Refer to: HNG-14/SS-23

This is in response to your February 19 office memorandum to Mr. Thomas O. Willett, which transmitted a crash test report on the subject breakaway device. This office was requested to determine the acceptability of the device for use on Federal-aid highway projects.

Geometric and Roadside Design Acceptance Letter SS-23

FIG. 1 - BREAKAWAY BASE DETAIL

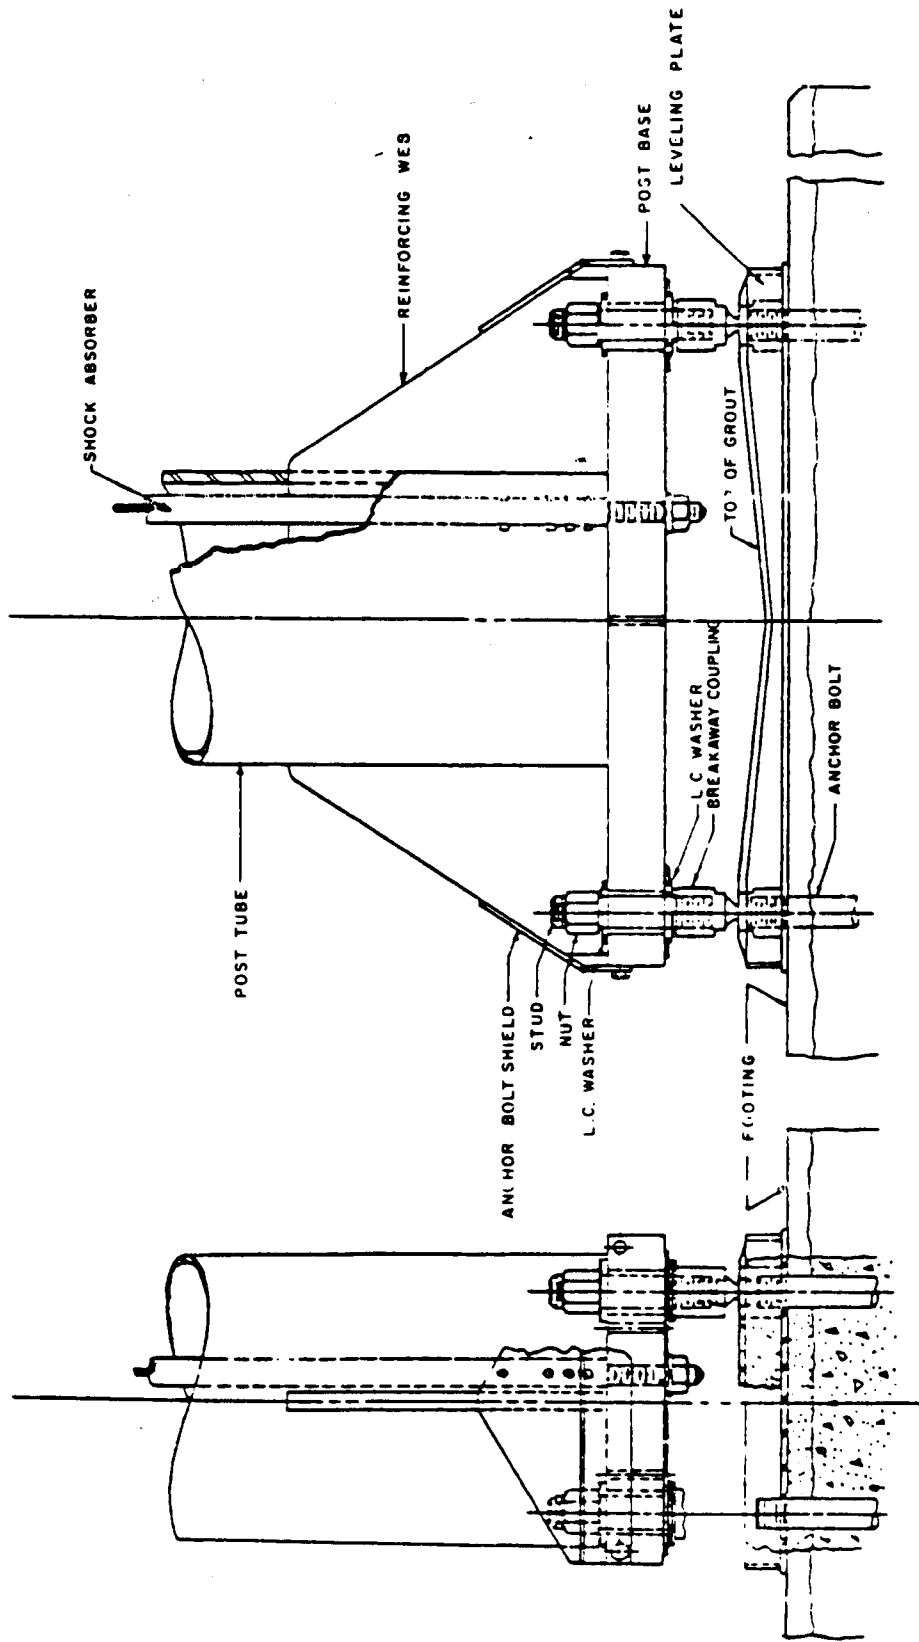
These results meet the change in velocity requirements of the AASHTO Support Specifications. Stub-height measurements were not available in this report, but it is evident that, as long as the base is installed low to the ground, it should be easy to meet the 4-inch stub-height requirement.

Thus, the New Jersey Breakaway Couplings are acceptable for use on Federal-aid highway projects within the range of conditions tested, if proposed by a State. This acceptance is limited to breakaway characteristics of the couplings and does not cover

their structural features. Presumably, New Jersey has investigated the structural design limitations and has detailed installation requirements to ensure proper performance. The State should have assurance from the fabricator that production couplings have essentially the same chemistry, mechanical properties, and geometry as those used in the tests. The State should also be prepared to certify that supports with those bases will meet the FHWA breakaway requirements.
